# **Response to Opinion ABP. Ref. 312265-21**

**Carmanhall Road SHD 2022**

**Strategic Housing Development for Build to  
Rent apartment development for 334 units at  
the former Avid Technology Site**

**August 2022**

**Figure 1 Map 3 – Building Heights of the Sandyford Urban Framework Plan 2022-2028**

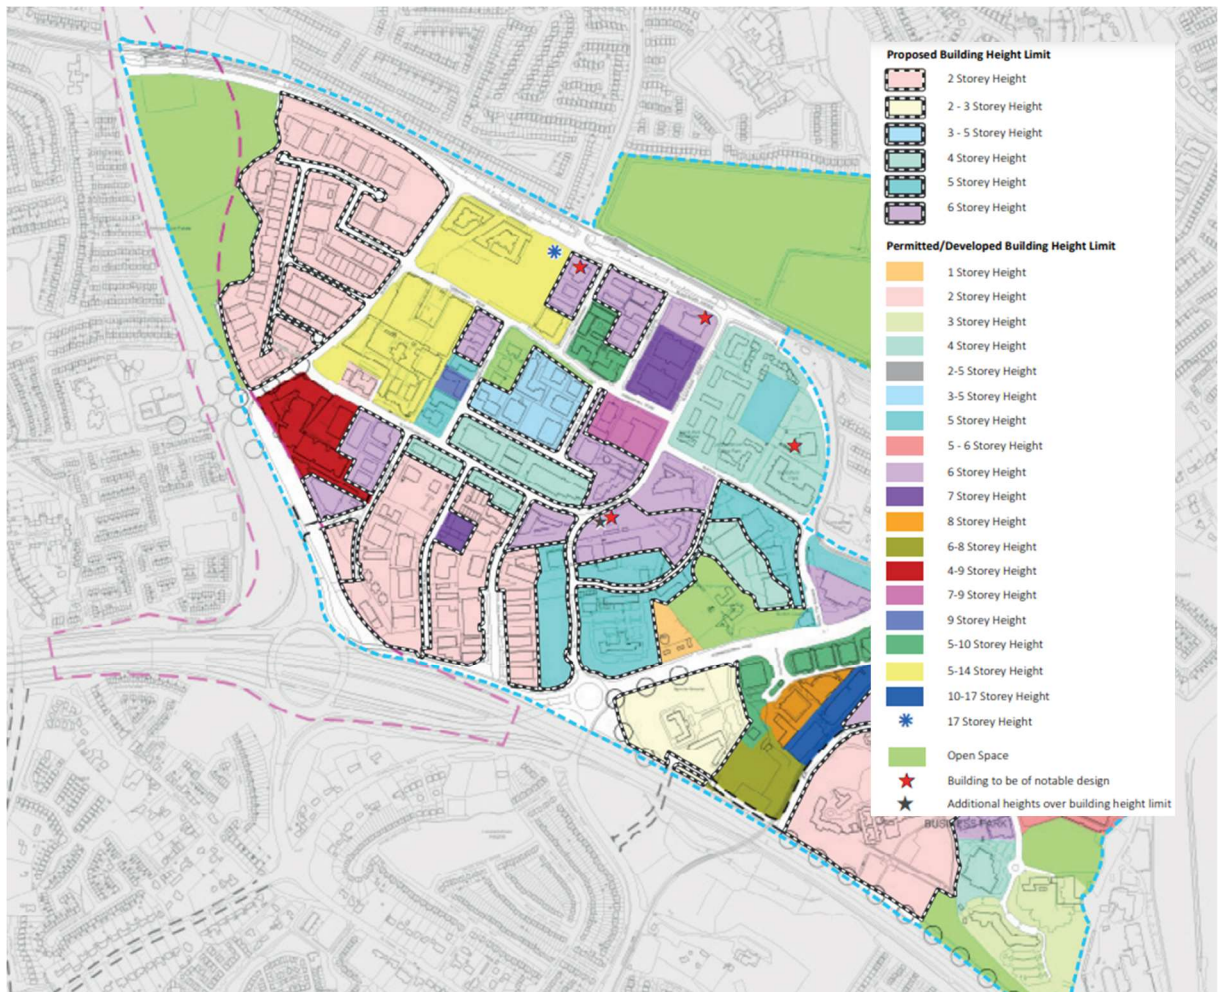
*DLR Co. Co. have referred to Policy UD6 of the County Development Plan and the Building Height Strategy (BHS) noting the SUFP does provide for 17 storey building heights in other locations, but that in this site Map 3 of the SUFP identifies a limit of 9 stories. DLR note that the applicant should provide justification for the proposed increased height in in this location.*

Map 3 of the Sandyford Urban Framework Plan 2022-28 sets out heights for individual parcels of land within the Sandyford Business District including the subject site which has been designated as having a permitted/developed height limit of 9 storeys (Figure 1).

***Additional height may be permitted where it can be demonstrated that additional height over the height limits identified on Map 3 accords with policy objective BHS1 and BHS2, of the Dun Laoghaire Rathdown County Development Plan 2022-2028, Appendix 5 subject to complying with the safeguards outlined in these policies as set out in Table 5.1 of the BH Strategy and any other development limits/phasing set out in the SUFP. Any application for increased height or taller buildings over and above the parameters set out in Map 3 shall be subject to assessment under policy objective BHS1 and BHS2 of the CDP.***

**Figure 2 Analysis of proposed building height above ‘shoulder height’ street frontage (Source: MDO Architects Design Statement)**

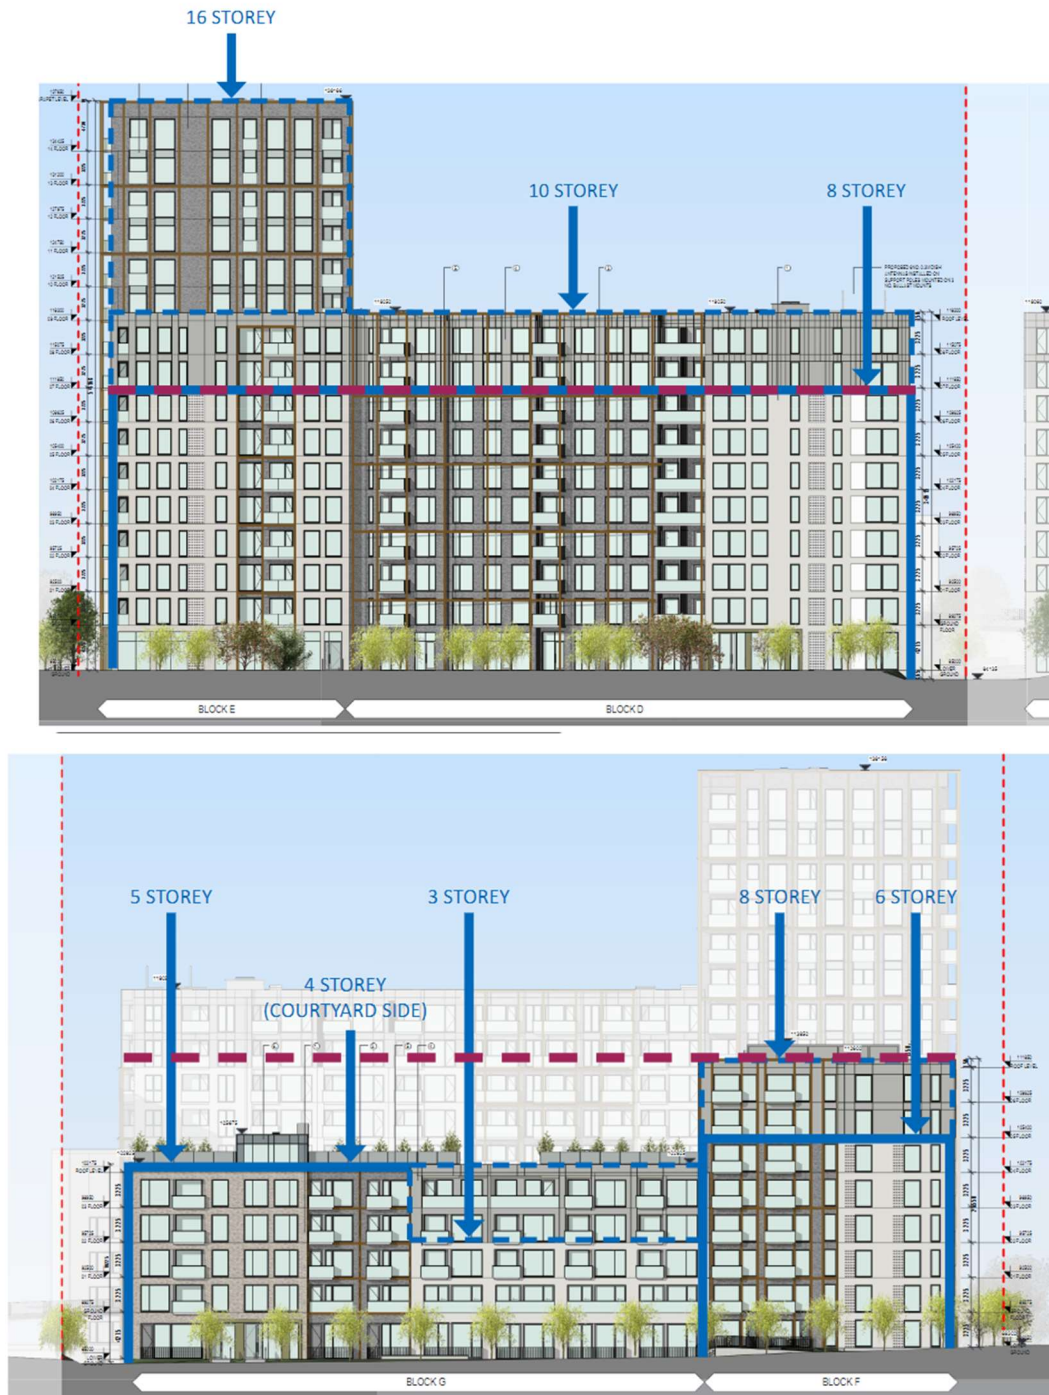
- (b) *Further consideration/justification of the documents as they relate to the Dun Laoghaire Rathdown Development Plan 2022 - 2028, specifically Appendix 5 and the Sandyford Urban Framework Plan, in relation to the scale, height, and design of the proposed development and the potential impact on the adjoining sites and surrounding environs of Sandyford. The further consideration/ justification should clearly address the proposed design and massing, inter alia the visual impact, and relate specifically to the justification for any material contravention of the density and height strategy in the development plan, issue of legibility, visual impact and compliance with Section 3.2 of the Urban Development and Building Heights: Guidelines for Planning Authorities (2018). The further consideration of these issues may require an amendment of the documents and/or design proposal submitted.*

Figure 2 below is from the Design Statement prepared by MDO Architects. It illustrates that the architectural elevations have been designed to a ‘shoulder height’ of 8 storeys to Carmanhall Road.

Block D on Carmanhall Road, has been designed to complement the existing architecture and carefully consider the heights allowed in the Development Plan. There is a clear shoulder height set out to follow the development objectives for the area at 8 storey. It is proposed to use predominantly brick for the 8 storeys defining the shoulder height. Vertical recesses in the facade add visual interest and break down the massing of the block further. Many of the

**Figure 4 Dún Laoghaire- Rathdown County Development Plan 2022-28 (Map 6)**

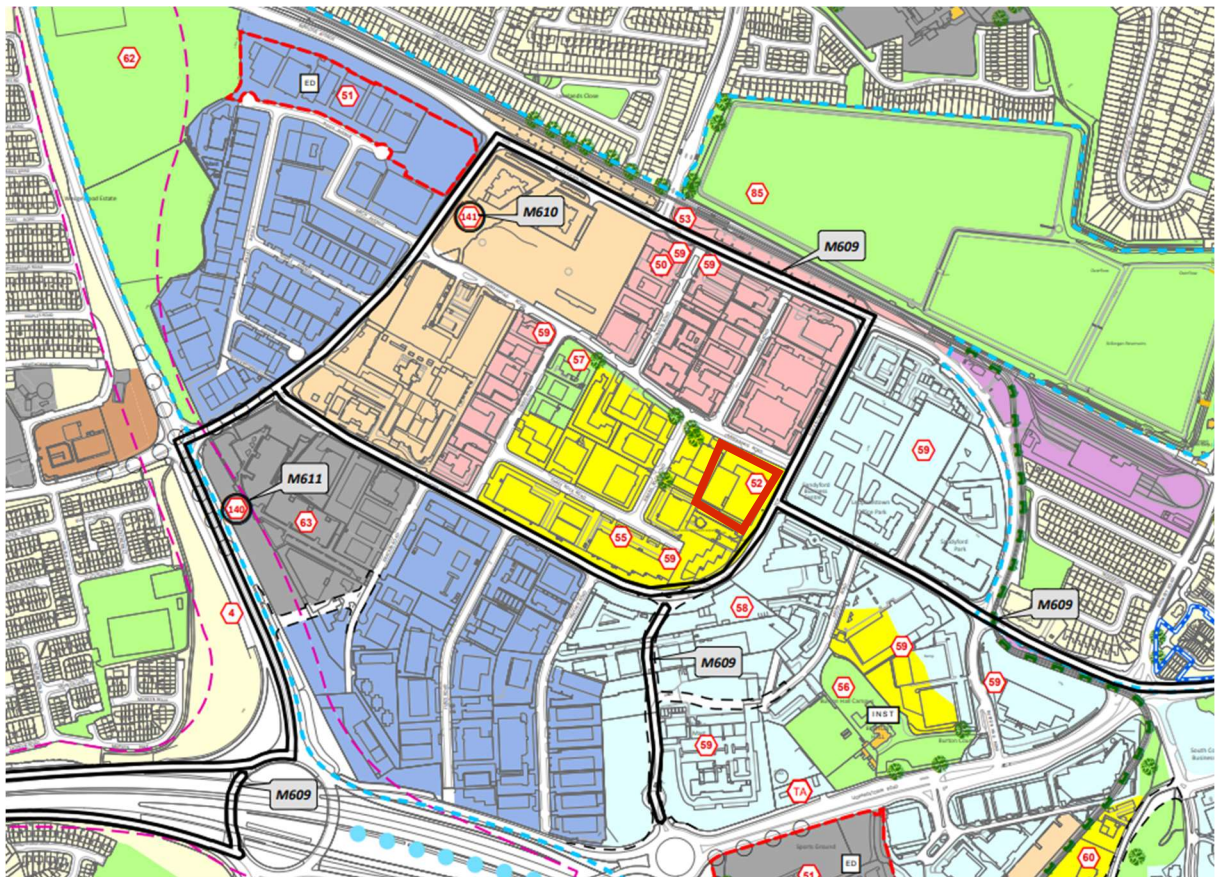
1. *In accordance with section 5(5)(b) of the Act of 2016, as amended, any application made on foot of this opinion should be accompanied by a statement that in the prospective applicant's opinion the proposal is consistent with the relevant zoning objectives of the development plan for the area. Such statement should have regard to the Dun Laoghaire Rathdown County Development Plan 2022 – 2028 and Sandyford Urban Framework Plan 2022, in particular SLO 113, in respect of any application for permission under section 4 of the Act.*

In this item the Board's Opinion refers to SLO 113. This was in fact an objective of the now expired SUFP 2016-22. This objective has been replaced by SLO 52 in the new Development Plan 2022-28 and the SUFP 2022-28. However, the Objective has remained consistent over the two plan periods.

In accordance with SLO 52, Community Infrastructure (Creche) and residential amenity spaces are placed at ground level on the Carmanhall Road to create active street frontage and is consistent with the Local Objective.

**Figure 5 Vehicular, pedestrian and bicycle access (Source: MDO Design Statement)**

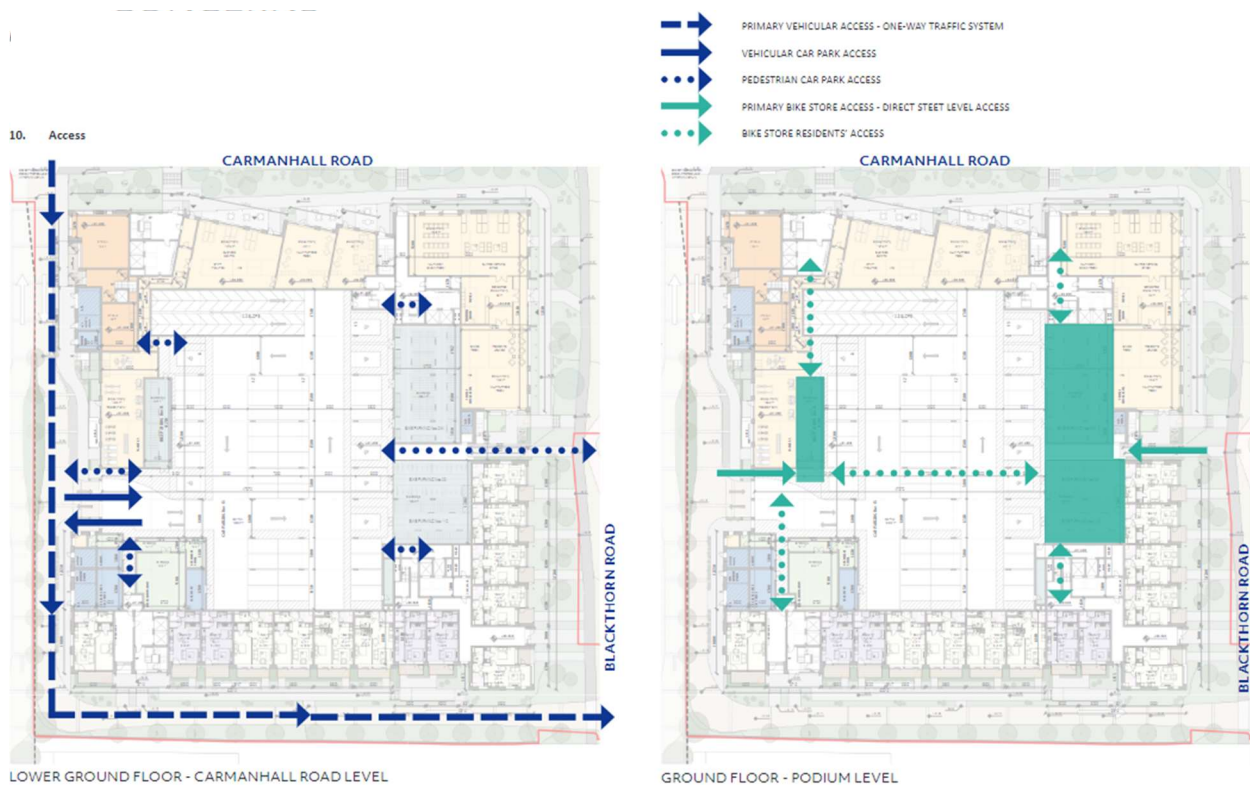
5. *Consider further the permeability of the blocks, pedestrian movement strategy between blocks, interface and access to podium level open space, clarity in relation to level changes, interface with proposed new streets, and potential conflict between pedestrians and vehicles using the basement access ramp/'street'.*

The Design Report by MDO provides detailed analysis of the urban design rationale for the layout of the proposed development independently and in the broader context of a masterplan with the adjoining Tack site.

**Figure 7 Extract from site plan illustrating location of Shared Amenity spaces (Source: MDO Design Statement)**

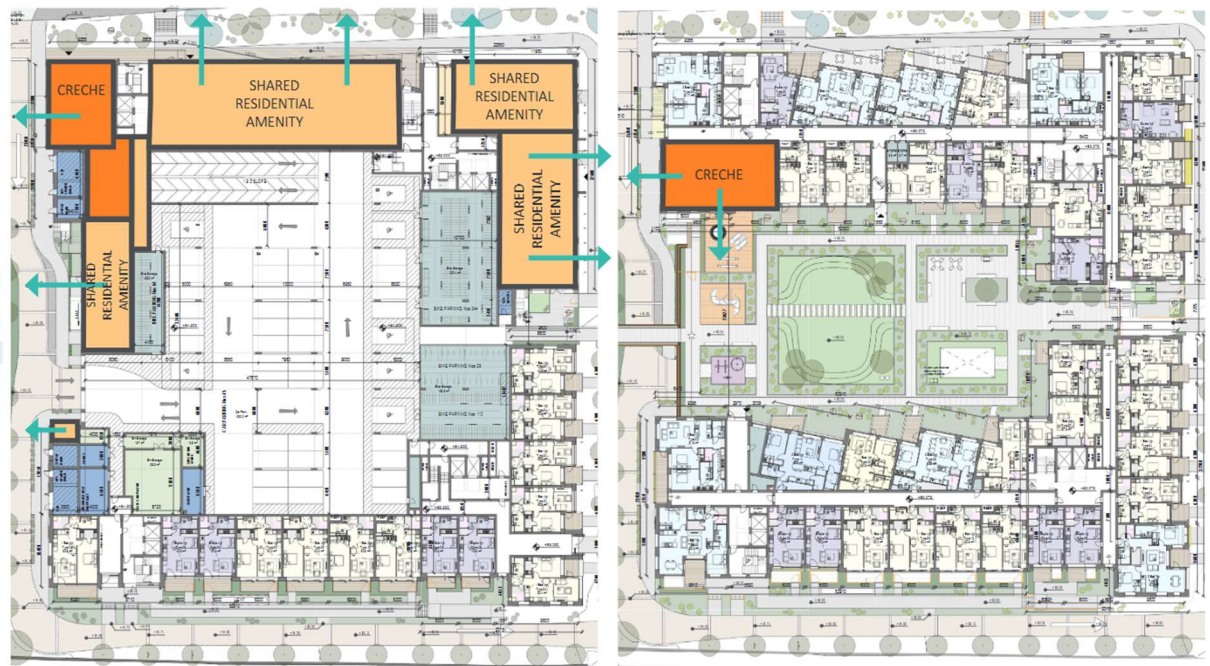
6. *Detail and justification of location and quantum of resident support facilities and resident services and amenities as defined by the Sustainable Urban Housing Design Standards for New Apartments Guidelines (2018) and accessibility/ease of access to those spaces by future residents.*

It is proposed to provide a variety of shared residential amenities on the lower ground floor of Block D and E overlooking DLR green verge on Carmanhall Road and Blackthorn Road, creating an active frontage and extend of the mix uses available in the development. It is proposed to provide 893 sqm of high quality shared residential amenities in Blocks D and E, 2.6 sqm/residential unit. These areas have a direct street access of Blackthorn Road, Carmanhall Road and inner street to the west.

These will activate the street frontage onto all three streets and provide generous spaces for the residents of all blocks to meet, relax and exercise together, reinforcing a sense of community. The proposed shared residential amenities include a resident’s lounge, co-working spaces, business centre, multipurpose room, staff facilities, resident’s gym, and entertaining spaces.

**Figure 8 Proposed amenity areas (Source: NMP Landscape Architects)**

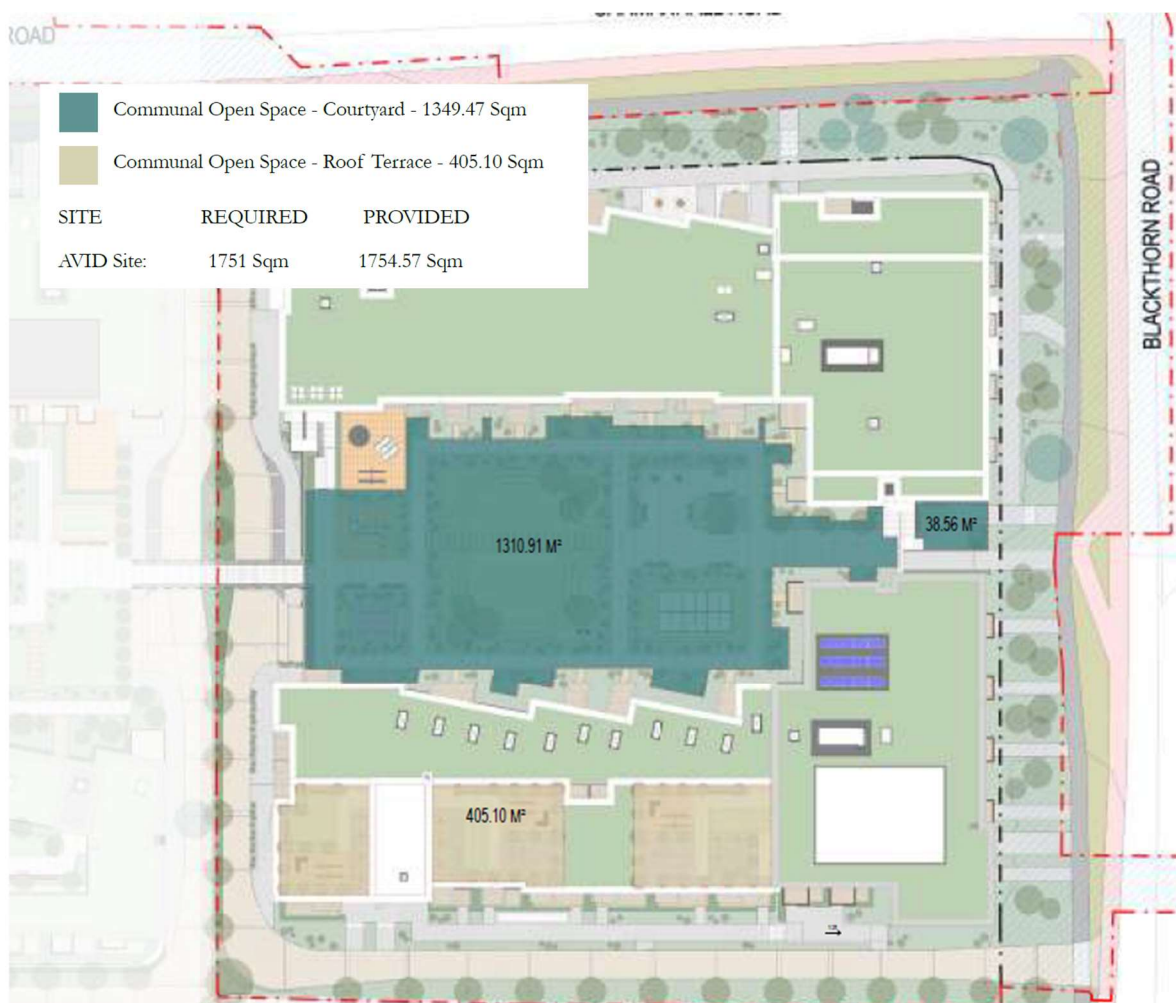
7. *Detailed quantum and design of open space proposals at all levels including consideration of issues related to wind micro-climate, design, and usability of spaces, in particular at the upper levels, and any implications of the green / blue roof design.*

The Landscape Design Report prepared by NMP Landscape Architects provides detailed information on the proposed public realm improvements and quantum of communal open space. Analysis of sunlight and daylight is provided in the report by IN2 which is addressed under the next heading. In summary, the quantum of open space is summarised in the following graphic from the NMP Landscape report.
